Access Compliance Report

Public Rights-of-Way

(Curb Ramps)

Intersection ID: 53930	Main Street: STARNES RANDALL RD	Cross Street: BRITTONDALE LN	Location: NW
ADA ID: 2C96018434C0	Ramp Type: Perp	Initial Pass/Fail: Fail	Overall Compliance: No
Severity Score: 47.5			
Codes/Mitigation Info/Possible Solution		Field Measurements/Component Compliance

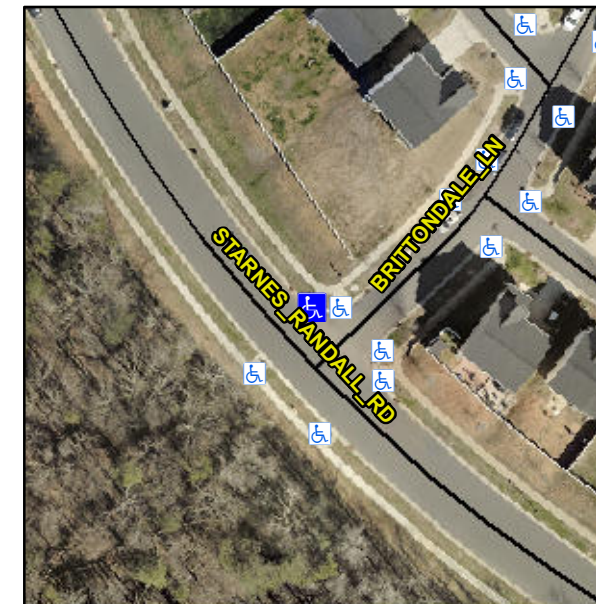
Not Found, R304.5.1, R304.5.3

Compliance	Description	Data	Compliance	Description	Data
N/A	Ramp Length (in)	95.0	Yes	Ramp Slope (%)	6.7
No	Ramp Width (in)	29.5	No	Ramp XSlope (%)	6.7
N/A	Flare Type LT	N/A	N/A	Flare Type RT	N/A
N/A	Flare Slope LT (%)	N/A	N/A	Flare Slope RT (%)	N/A
N/A	Flare Traversable LT?	N/A	N/A	Flare Traversable RT?	N/A
N/A	Landing Length (in)	N/A	N/A	DWS Provided?	N/A
N/A	Landing Width (in)	N/A	N/A	DWS Contrast?	N/A
N/A	Landing Slope (%)	N/A	N/A	DWS Length (in)	N/A
N/A	Landing X Slope (%)	N/A	N/A	DWS Full Width?	N/A
N/A	Landing Curb? (Y/N)	N/A	N/A	DWS Offset (in)	N/A
N/A	Shared Landing?	N/A			
N/A	Gutter Ponding?	N/A	N/A	Gutter Slope (%)	N/A
N/A	Gutter Lip Ht (in)	N/A	N/A	Gutter X Slope (%)	N/A
N/A	Painted X Walk1?	No	N/A	Painted X Walk2?	N/A
	X Walk 1 Direction	To SW		X Walk 2 Direction	N/A
N/A	X Walk 1 Width (in)	N/A	N/A	X Walk 2 Width (in)	N/A
	X Walk 1 Slope (%)	0.4		X Walk 2 Slope (%)	N/A
	X Walk 1 X Slope (%)	7.2		X Walk 2 X Slope (%)	N/A

Remove & Replace Entire Ramp.
